Third Addendum to the Los Angeles Memorial Coliseum Renovation Project EIR

Existing and Proposed Video Board Graphics

**Los Angeles Memorial Coliseum
Potential Impacts of Approved vs. Modified
Project on Character-Defining Features
Review of Additional Modifications
Third Addendum, November 23, 2016**

EXISTING SCOREBOARDS TO BE REMOVED

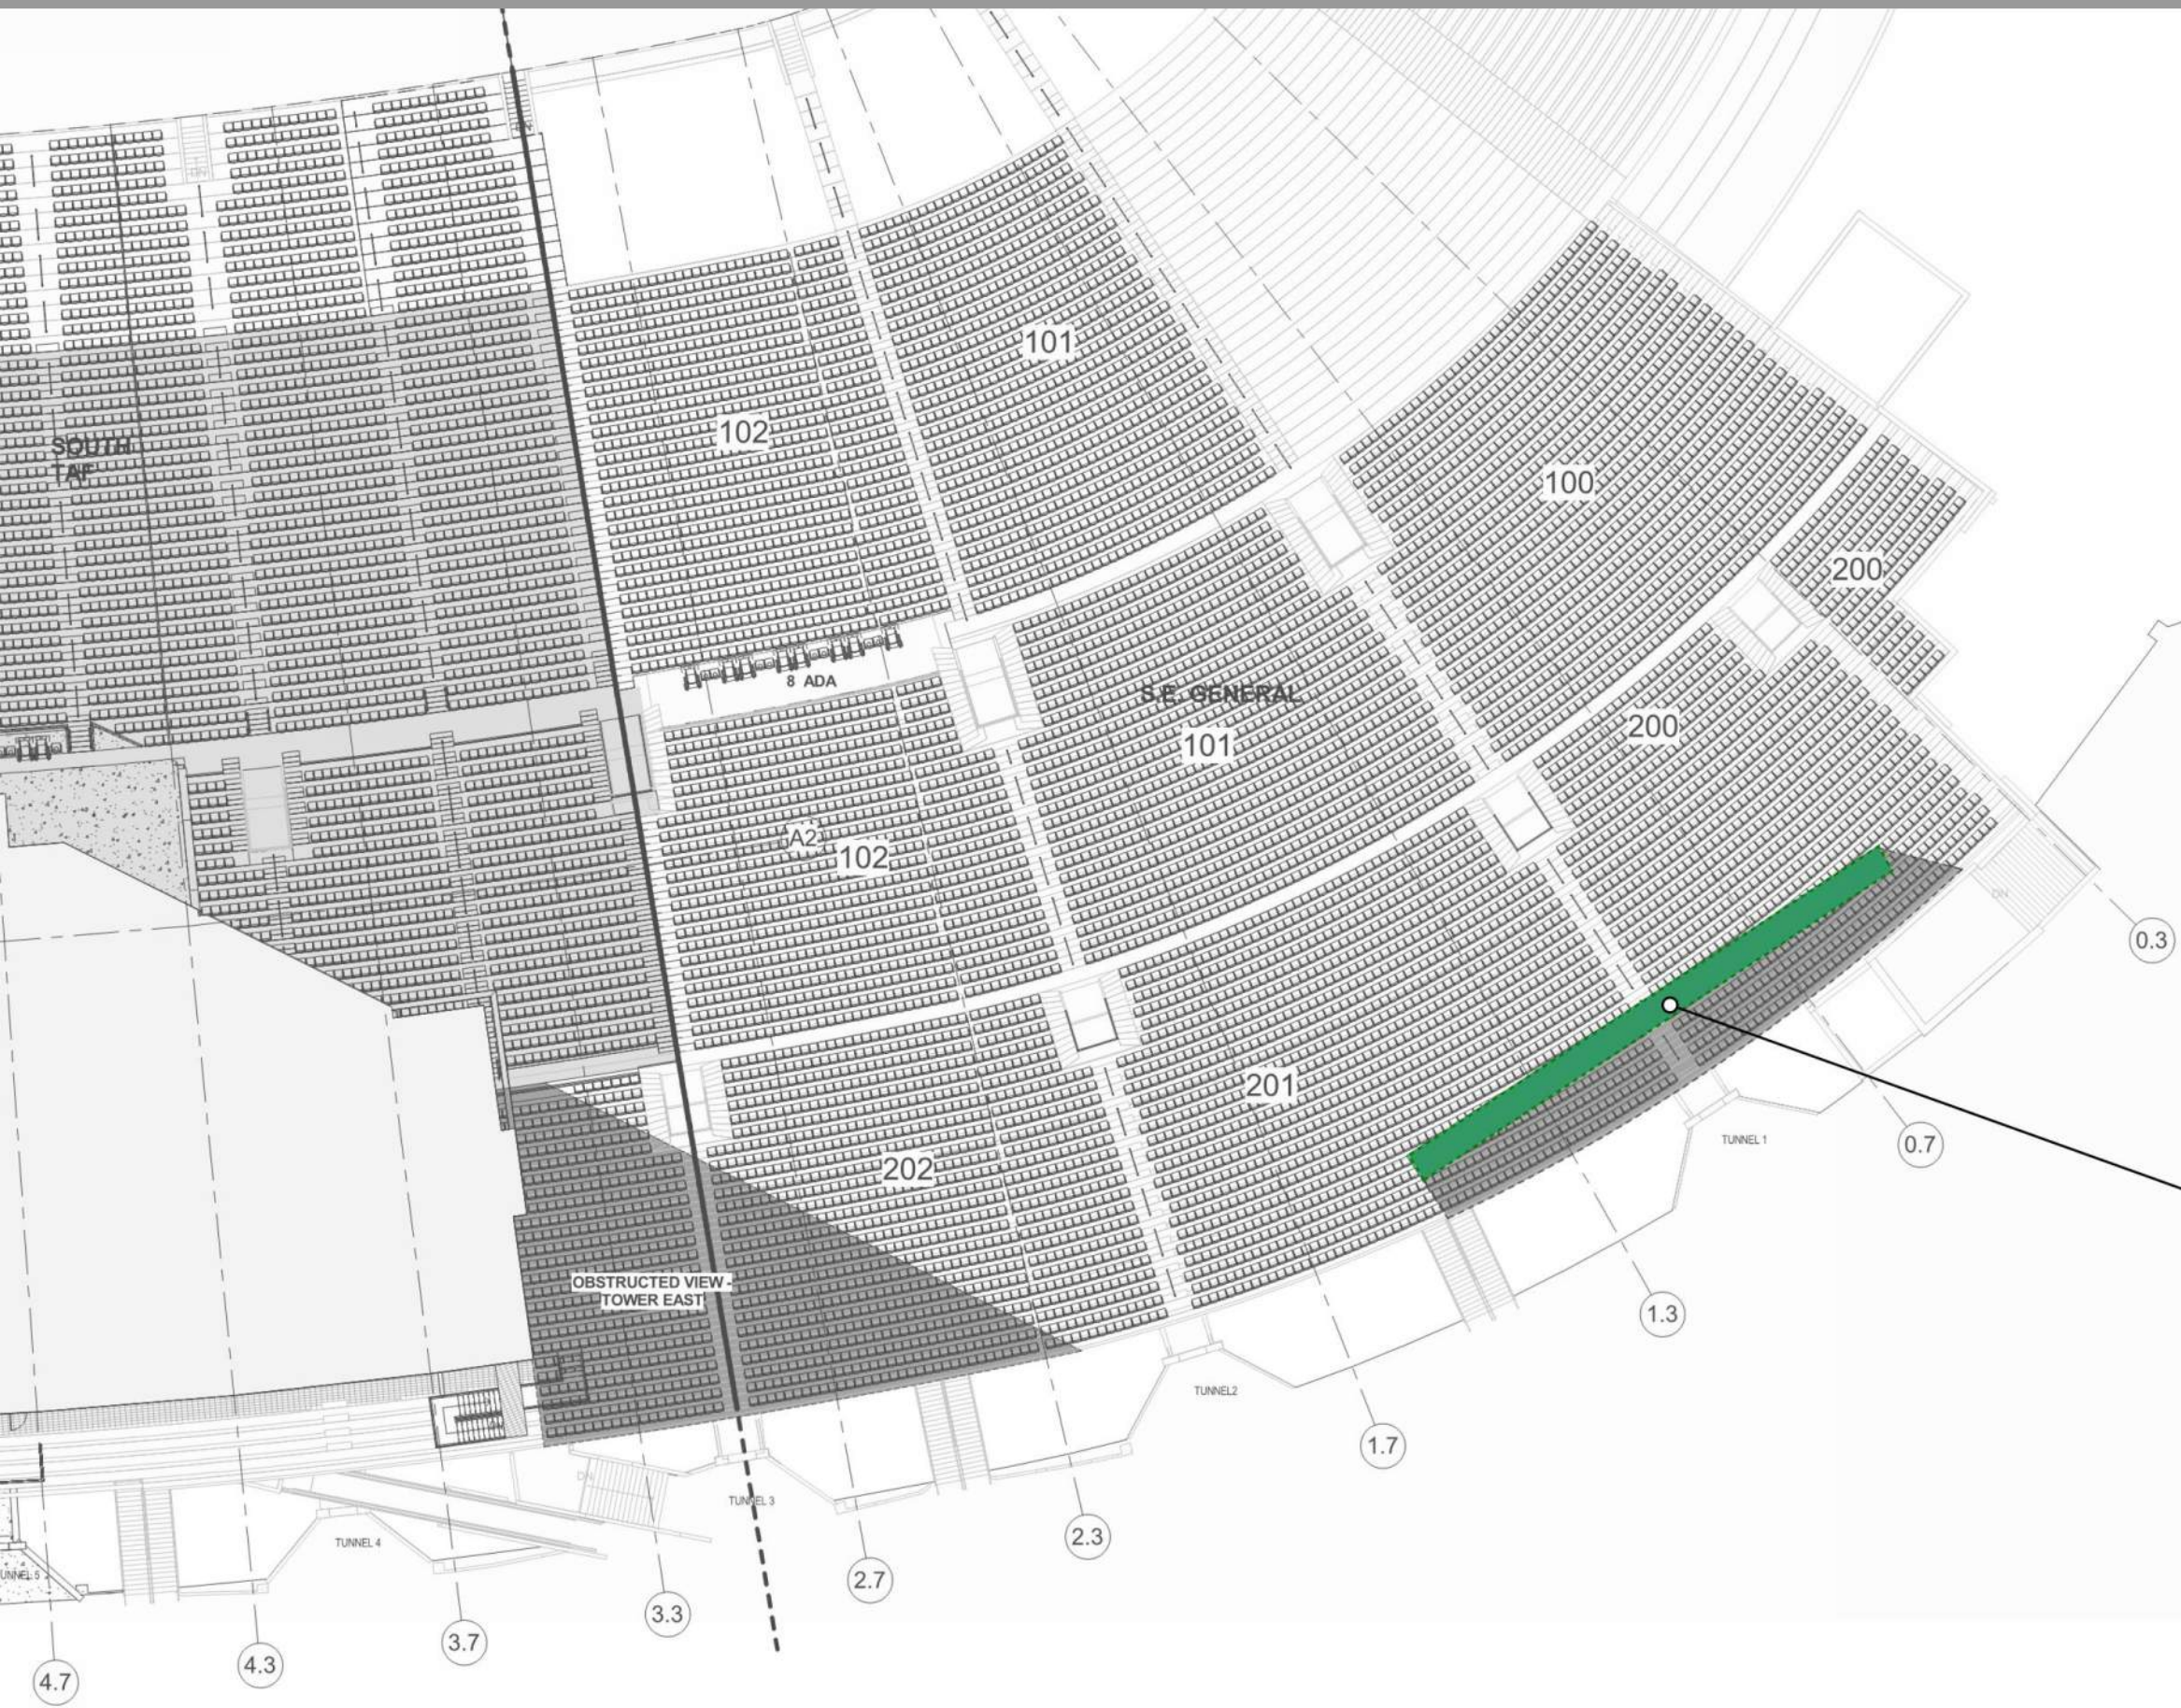
As shown in the graphic materials provided in Attachments A and B, as with the renovation project as described in the Second Addendum, under the current proposal the video boards that are currently located on top of the Peristyle would be removed and replaced with video boards that would be integrated with the seating bowl. The center Peristyle game clock would also be replaced by a modern smaller integrated game clock. However, USC proposes to move the location of the two added video boards a relatively small distance higher up the bowl, outward from the field, nearer the rim wall, in order to meet the minimum acceptable lines of sight from general seating.

SECTION OF PROPOSED SCOREBOARD

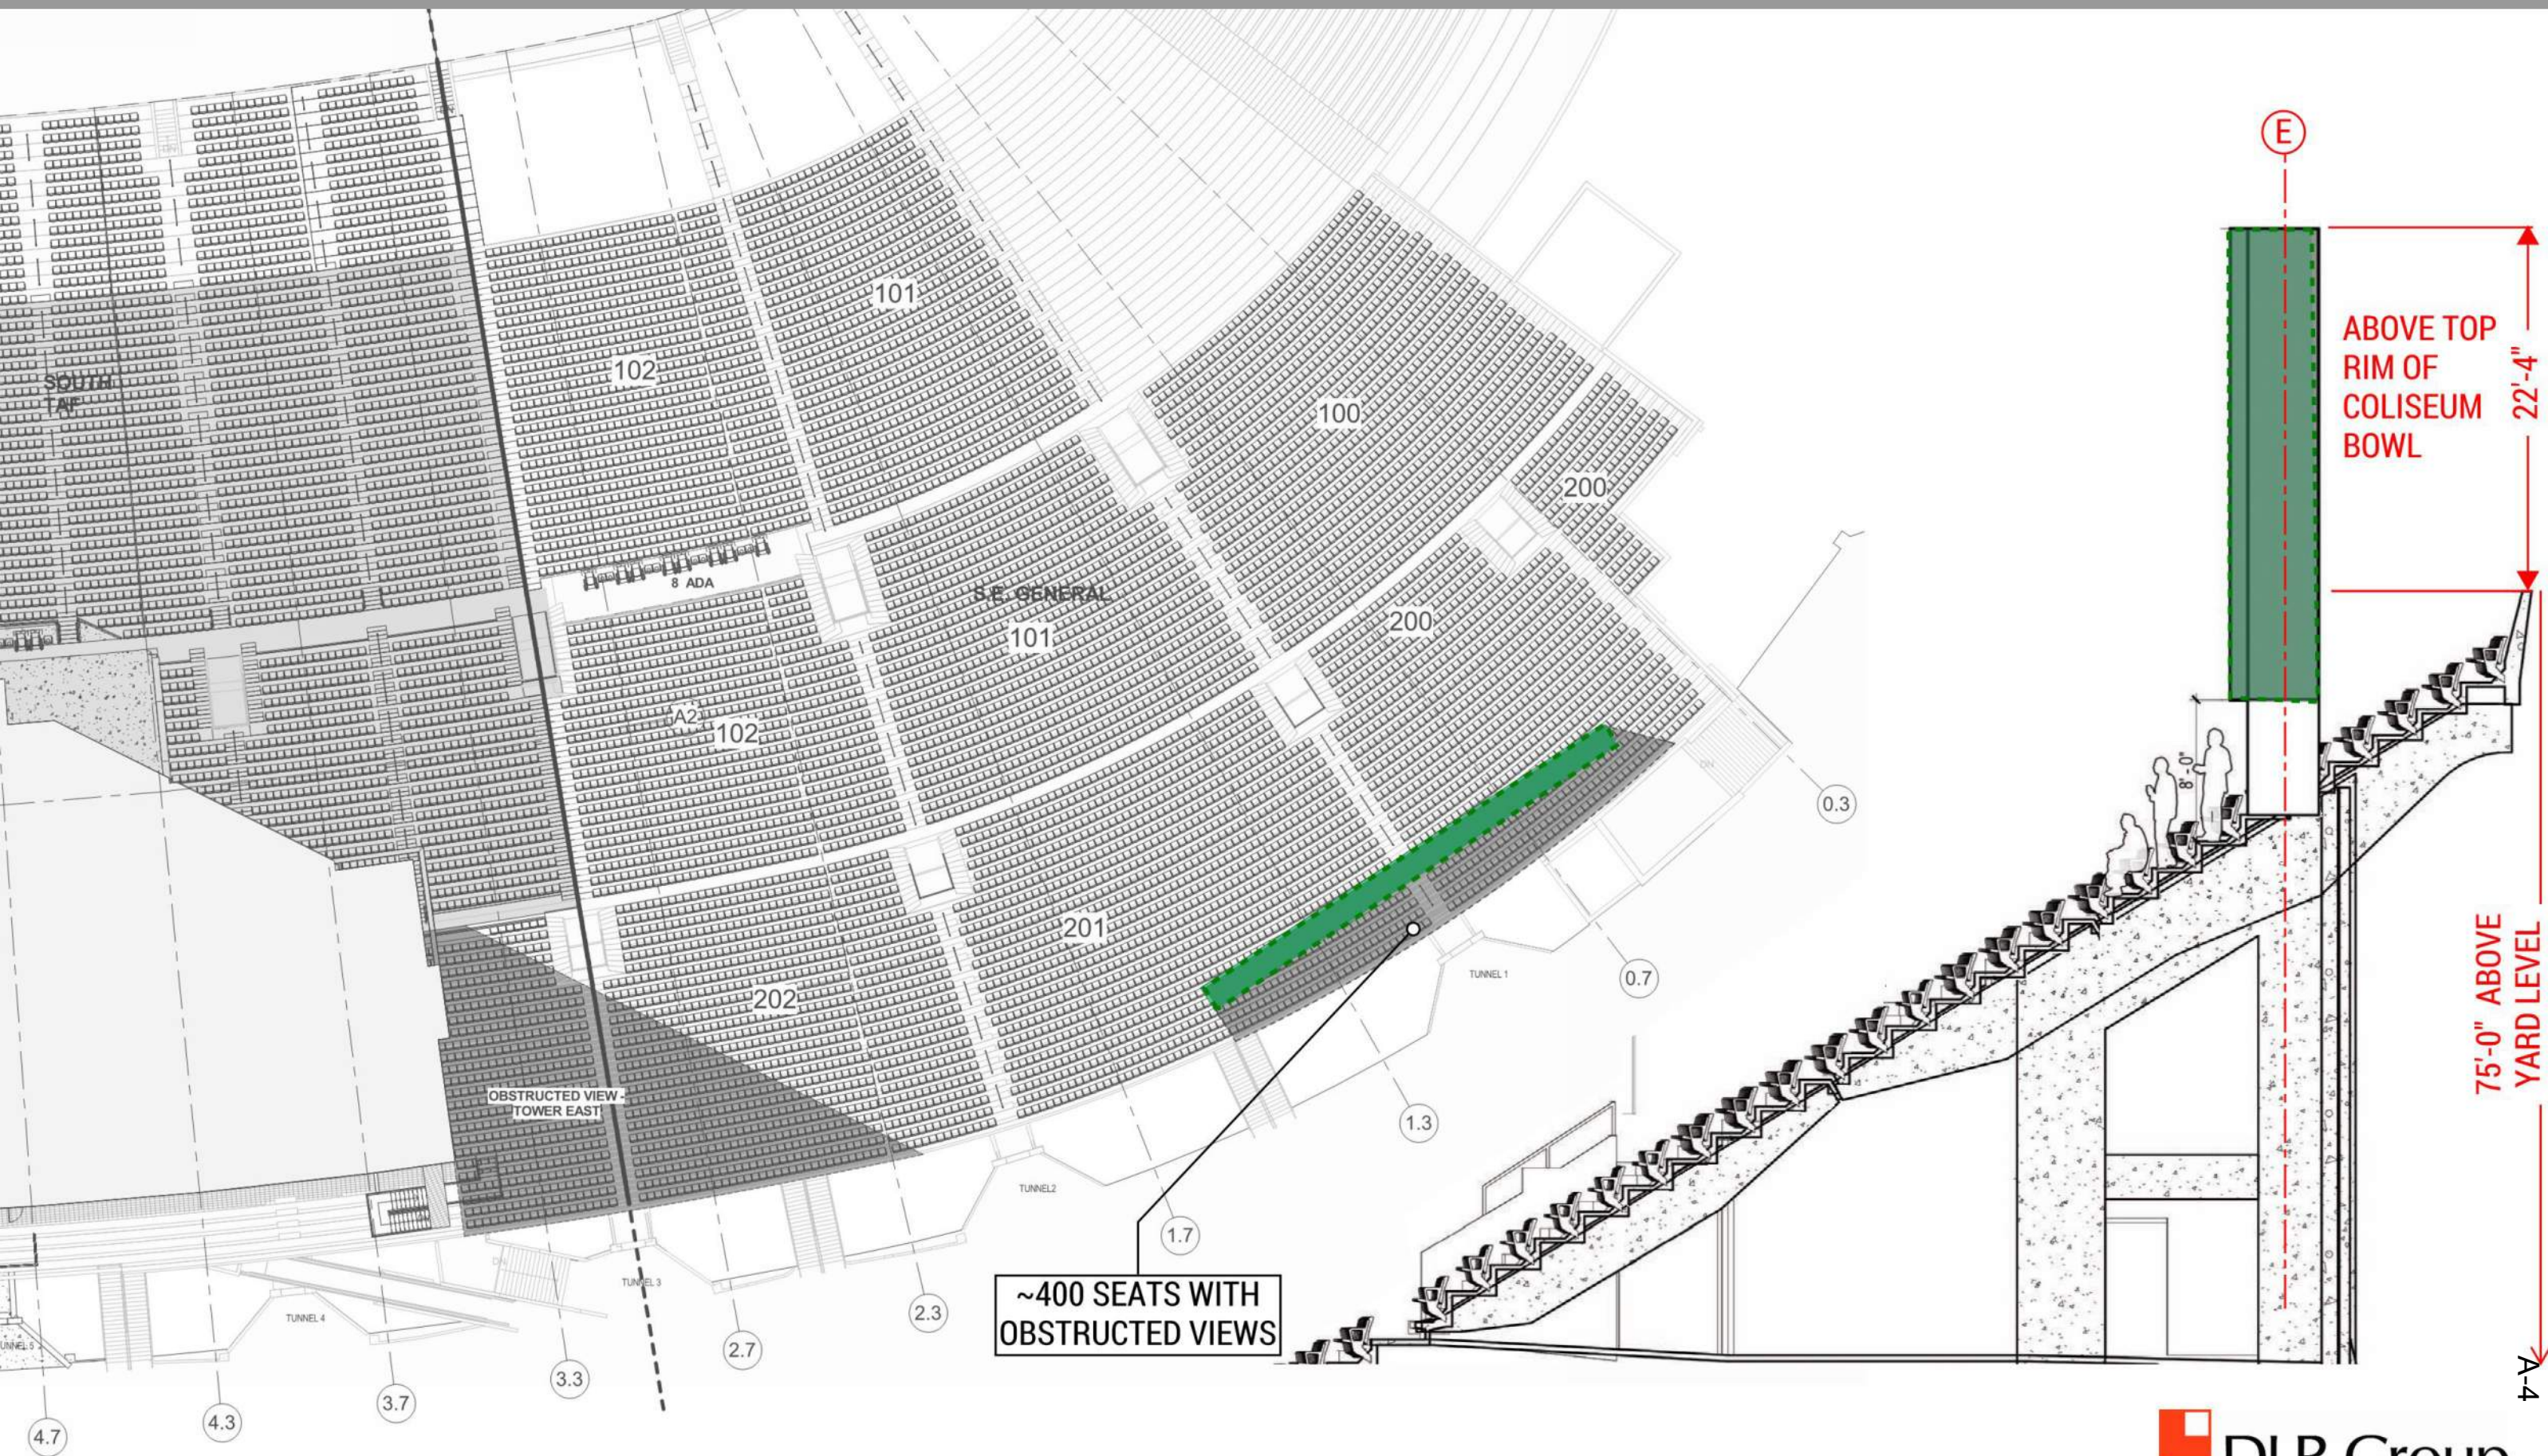
This option is mirrored in the NE corner of the Coliseum as well.

SCOREBOARD
Supported by existing bowl
columns along grid E.

Support columns rest on existing bowl columns along grid E.

VIEWING ANGLES WITH PROPOSED SCOREBOARD

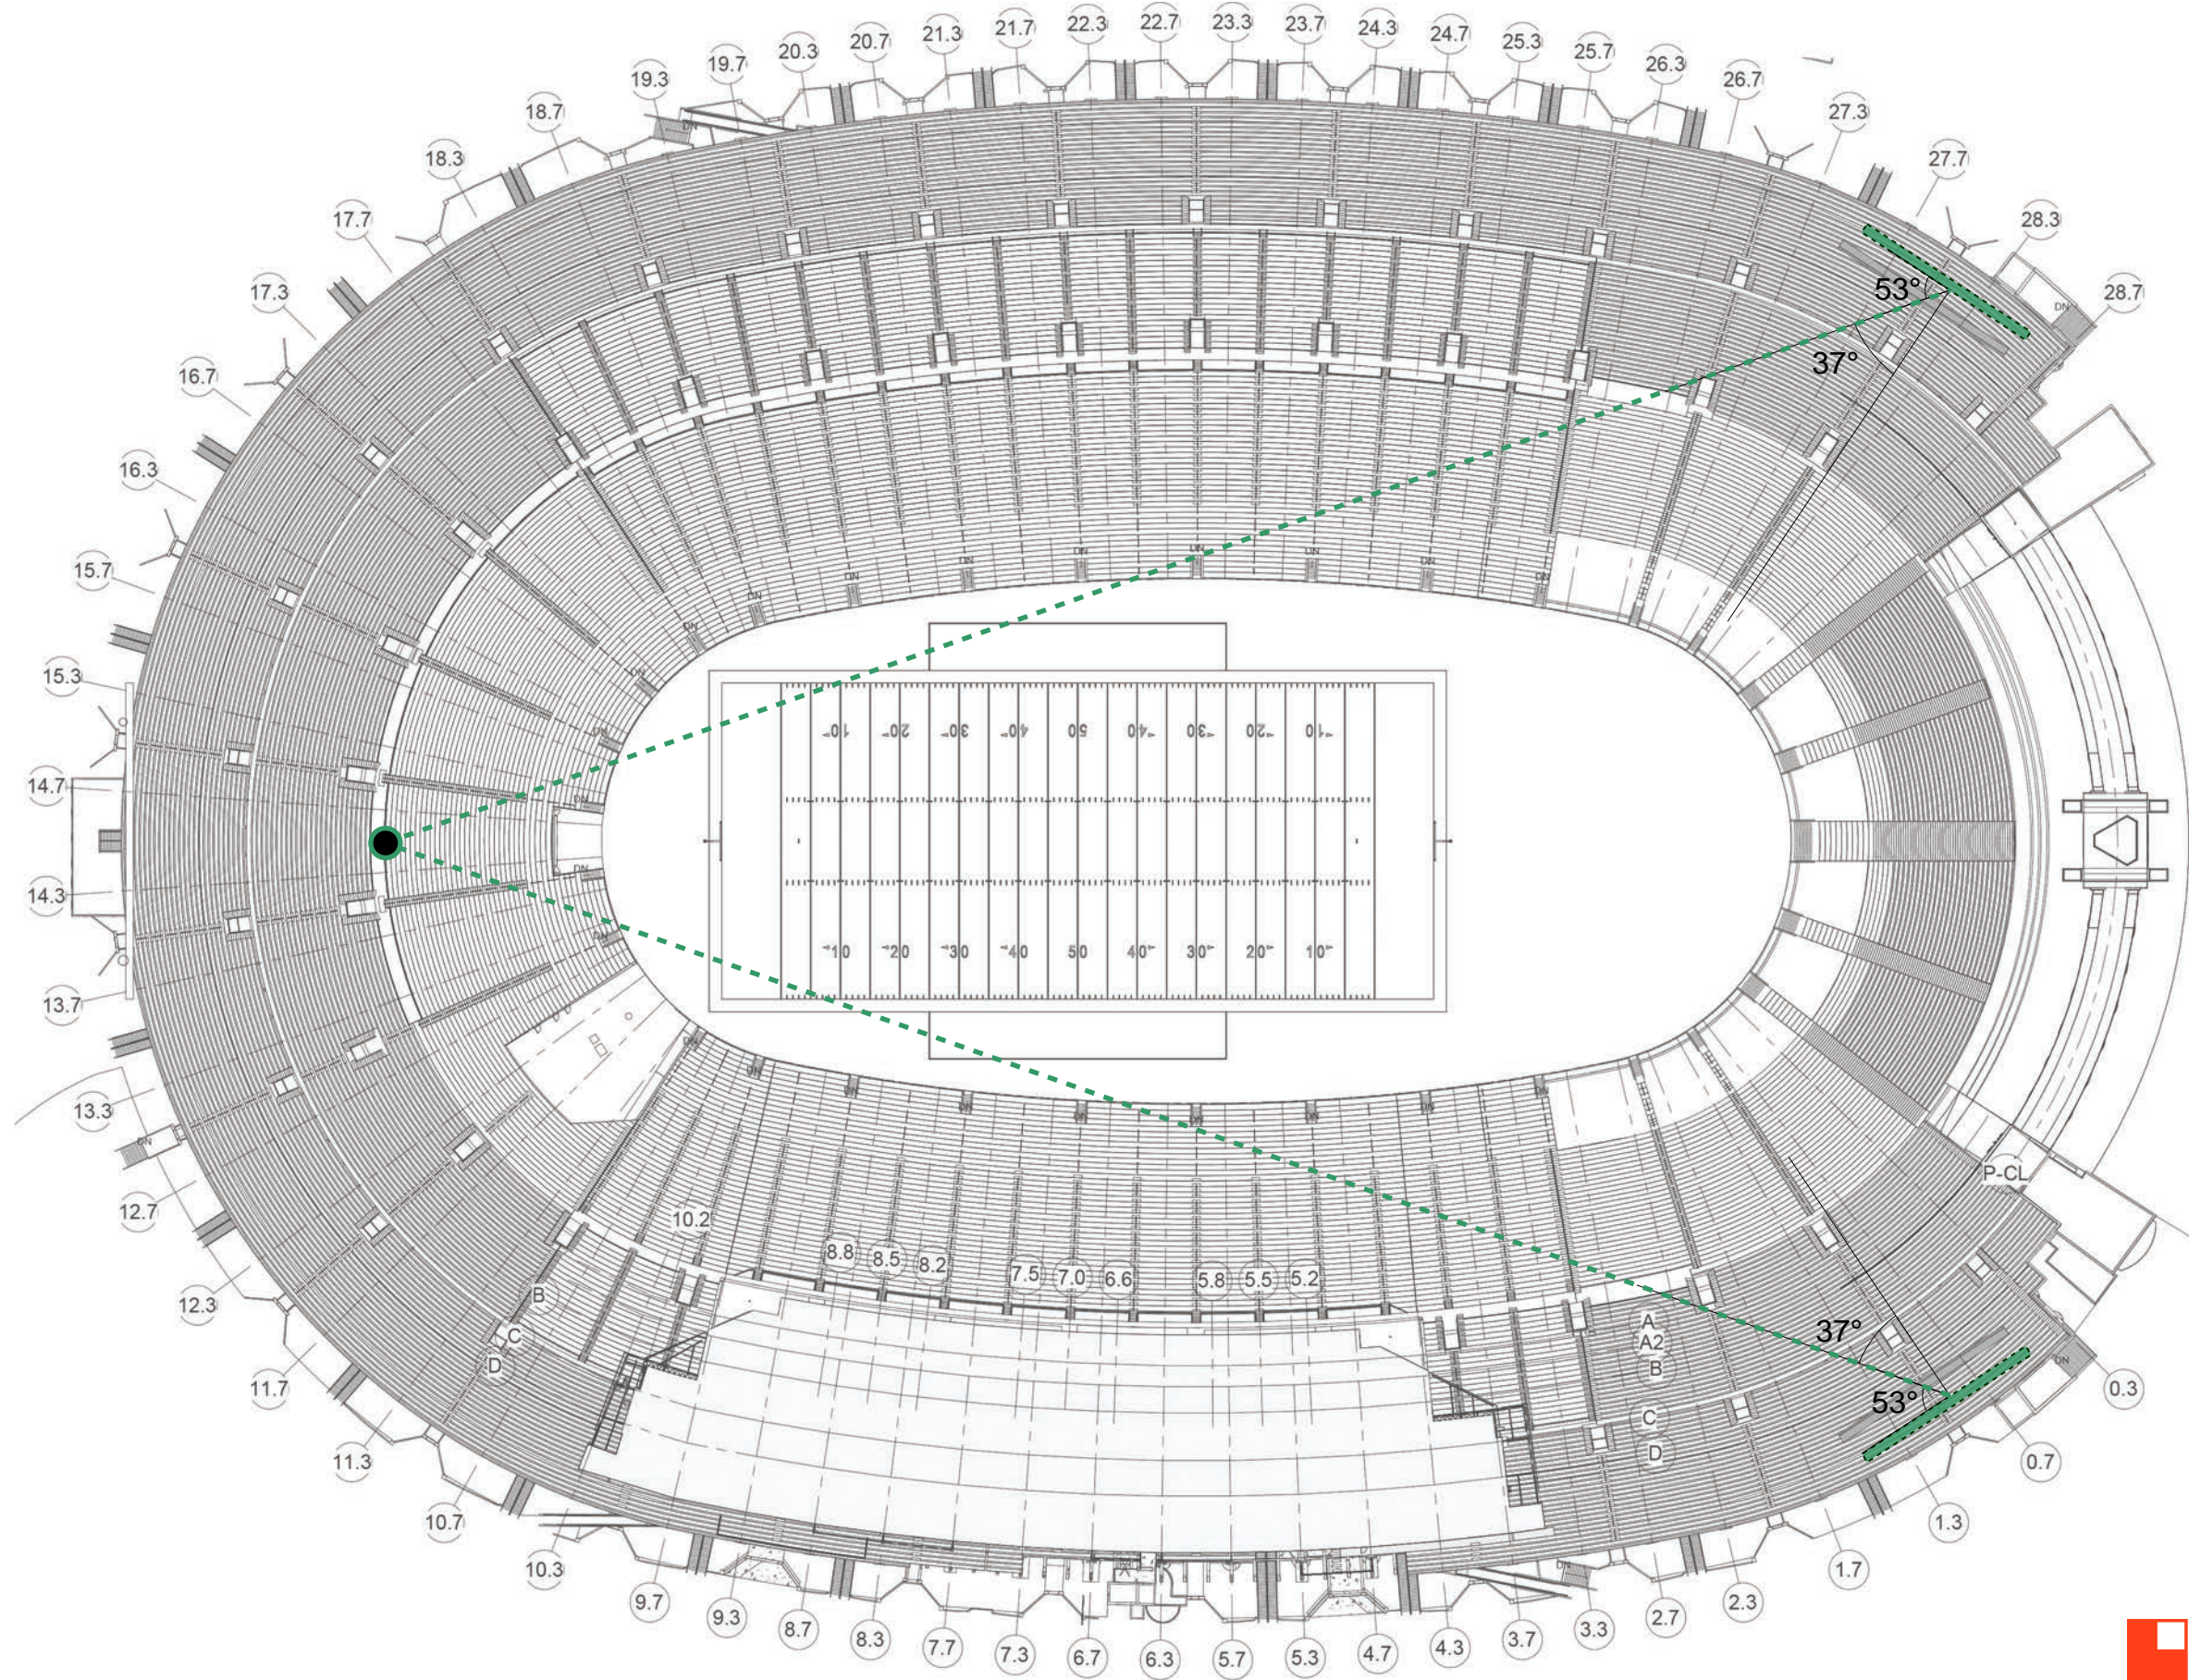
~400 SEATS WITH
OBSTRUCTED VIEWS

75'-0" ABOVE
YARD LEVEL

Viewing angle is within recommended criteria.
